# Service Advisory

MTD-085

**Models Affected:** White Outdoor Products 54" RZT - 17AK2ACK090; 17AK2ACK290 and 17BK2ACK090  
**Serial Number Range Affected:** 17AK2ACK090 - 1/02/2008 (Date Code"...A028...") thru 1/30/2008 (Date Code"...A308...")  
 17AK2ACK290 - 2/19/2008 (Date Code"...B198...") thru 3/17/2008 (Date Code"...C178...")  
 17BK2ACK090 - 12/20/2007 (Date Code"...L207...")

**Subject:** Product Update - 54" Deck Movable Idler Spring

FIGURE 1

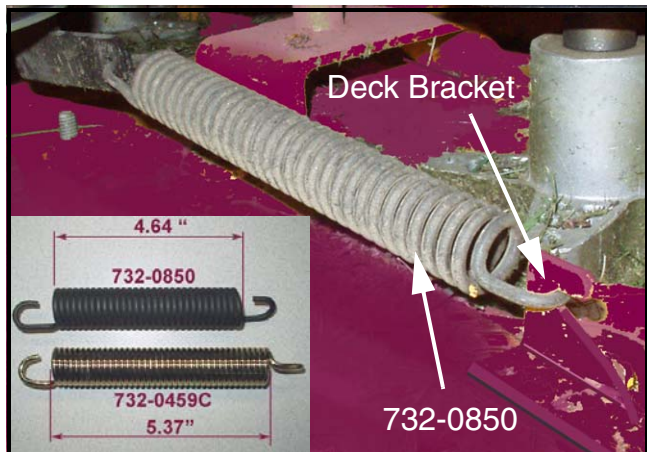
1. Place rider on a flat and level surface, disengage the PTO, turn off engine, remove ignition key and engage the parking brake ON.
2. Position the cutting deck to the lowest cutting height.
3. Inspect the deck idler tension spring. See Figure 1.

If the deck's idler spring is yellow/gold in color, the idler spring has already been updated to the **732-0459C**. **Stop Here**, this advisory has been addressed.

If the spring is black in color, (**732-0850**) see Figure 1, proceed to Step 4.

FIGURE 2

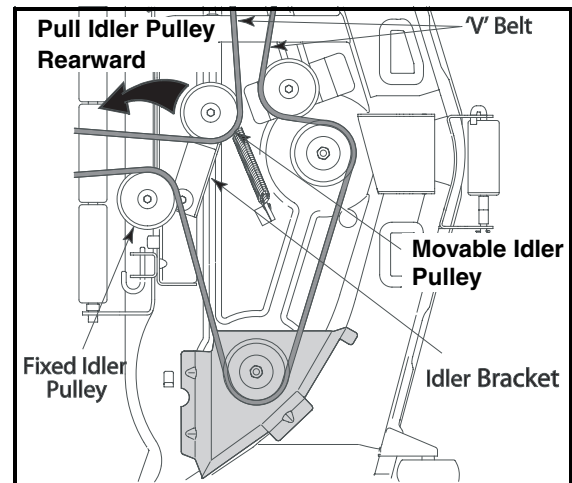
5. Using the deck lift handle, raise the deck to the position that provides the most horizontal path of the belt between the deck idler pulleys and the PTO pulley on the bottom of the engine.
6. Working from the middle of the tractor, pivot the idler bracket and movable idler pulley rearward away from the back side of the "V" belt just far enough to lift the belt up and over the idler pulley. See Figure 2.

7. Unhook the black idler spring from the deck bracket, then unhook the spring from the idler bracket. Discard the spring.
8. Install the new **732-0459C** spring (yellow) and re-install the deck drive "V" belt in the reverse order of idler spring removal.
